Organisations: Worcester St Cycleway

Spokes Submission to CCC on Worcester Street cycleway connection
<https://ccc.govt.nz/the-council/haveyoursay/show/488>

LOOKING WEST FROM LATIMER SQUARE

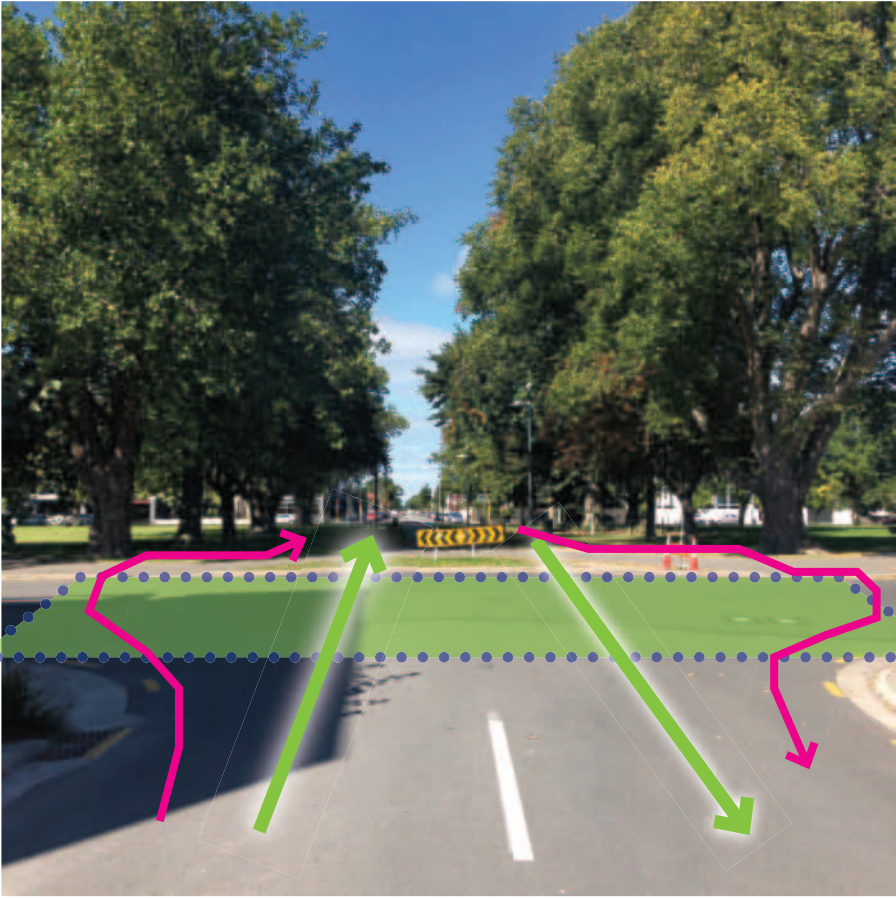
- Currently awkward to cycle from Latimer Square up Worcester Street.
- The proposed changes do not address this uncomfortable route.
- An offset layout encourages cyclists to use the footpath along Worcester Street rather than the road. Perhaps not a bad thing if it's a shared footpath, but is that the intention?
- How will the proposed sharrows improve this route and cyclist safety?
- How will sharrows help cyclists at this intersection in an area forecast to be denser and busier?

- Could the cycleway be aligned with Worcester Street itself?
- A raised crossing on a quiet street would cater for future residents, pedestrians, visitors and cyclists, and would better connect the central city to Linwood and the Rapanui Cycleway.
- For a higher quality inner city residential, commuting and cycling experience wouldn't this be a better option? How would adding sharrow markings to the existing layout achieve this?

- Reiterating the awkward layout of the intersection for cyclists.
- How will sharrows make it better and safer for cyclists?
- Why not build a high quality, safer cycling infrastructure that will also benefit future residents of the East Frame's high density living, rather than mainly benefit vehicle traffic?

Latimer Square crossing at Madras Street looking east...

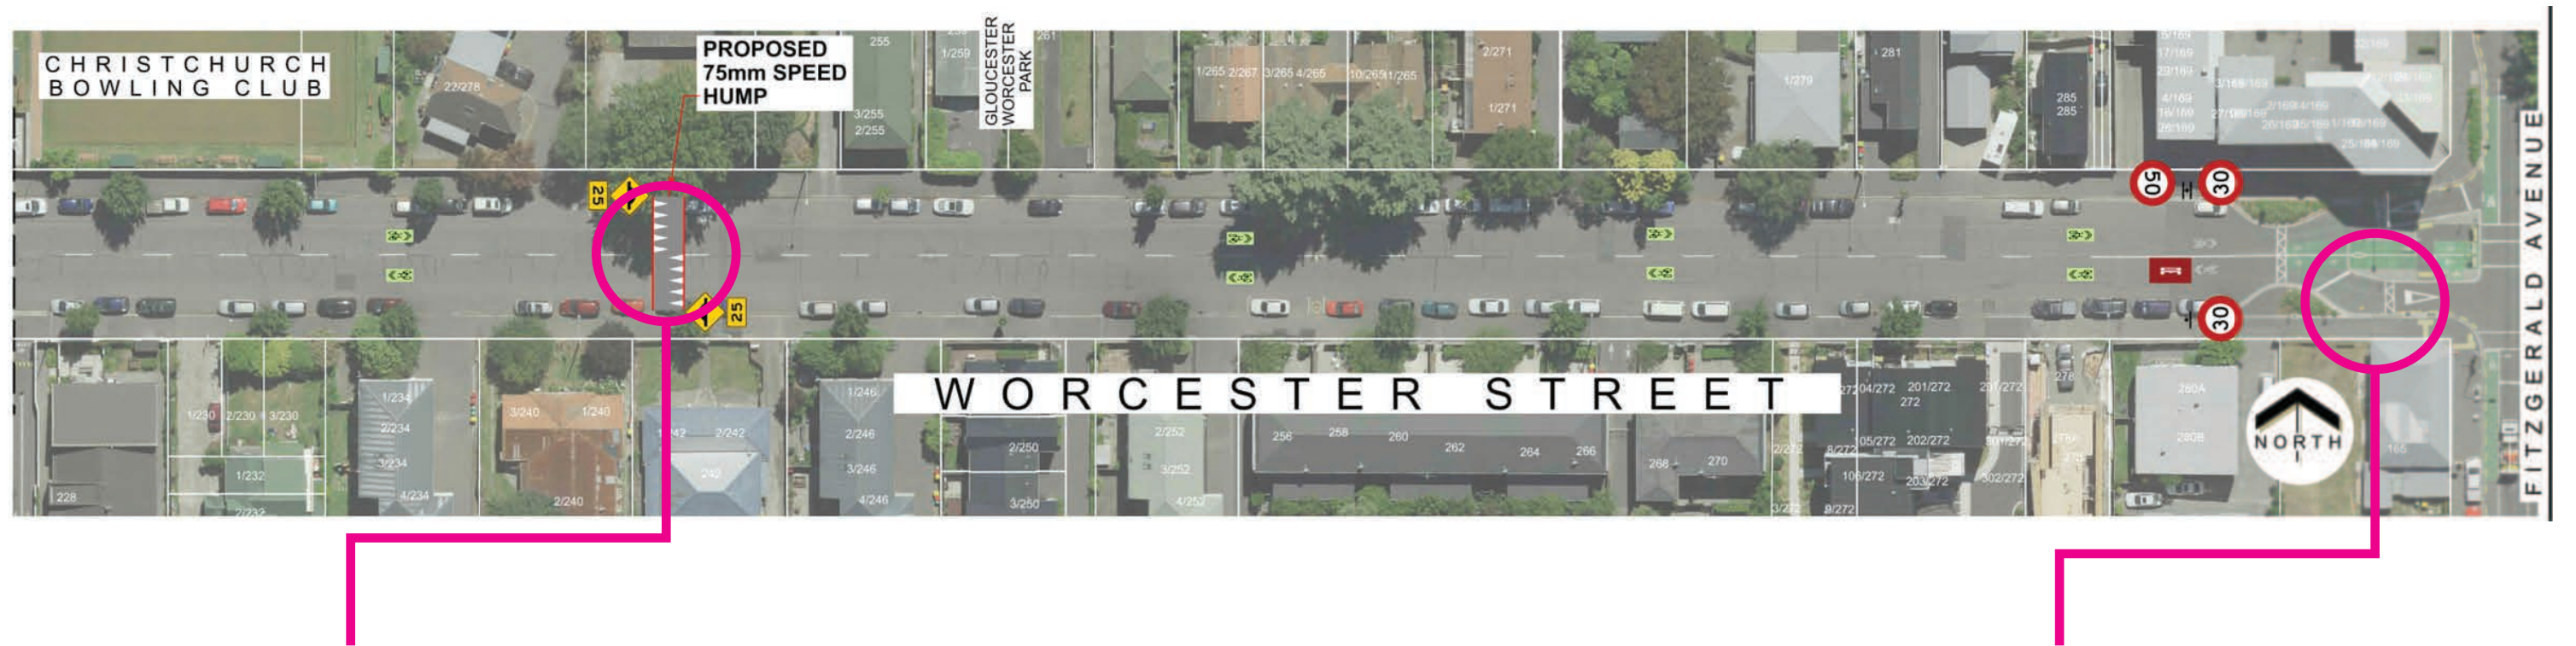
- This cycle stopping point could definitely do with markings
- This crossing is also a natural desire line for pedestrians, but no crossing exists for them.
- If *Project 8011* - the CCC's residential programme for the Central City - is to achieve its purpose of encouraging more people to make the Central City their home, then we need to properly implement better and more accessible cycling and pedestrian infrastructure.

- Parked vehicles regularly encroach upon this bike lane stopping point.
- The proposed markings will help define the space better but perhaps consider removing the car parking spaces which really constrict the space here. This would allow for a wider cycle lane plus a wider vehicle lane exiting Worcester Street.

- Most of the road surfacing in the Worcester Street block between Madras and Barbadoes is of poor quality. Sharrow markings will not address this issue. Is resurfacing planned?
- As a cyclist, this block of Worcester Street feels busier with faster traffic than the adjacent blocks. The proposed 30km/hr speed limit will help but the current road surfaces means staying to the left is an uncomfortable ride at times.
- Potentially this is the block that needs traffic calming at each end, to help enforce the new speed limits for vehicles exiting on to Worcester Street from Madras Street and from Barbadoes Street (both one-way systems where vehicles exceed the existing 50km/hr speed limits).

- A proposed speed hump is all well and good but if you want to enforce a reduced 30km/hr speed limit would be better to also have some traffic calming measures at each end of the block (i.e. for traffic turning in from Fitzgerald Avenue and from Barbadoes Street)?

- I love this intersection when cycling.
- I have been caught out a few times cycling west when a car has turned into Worcester Street from Fitzgerald Avenue and not wanted to merge properly. I'm not if further traffic calming measures are possible or practical wondered what other cycleway users' experiences were like at this junction.
- As a cyclist you still need to have your wits about you. Several times drivers have gone straight through the red lights when I've had the green light. A bit chastening. But I do like what CCC has done here. Thank you.
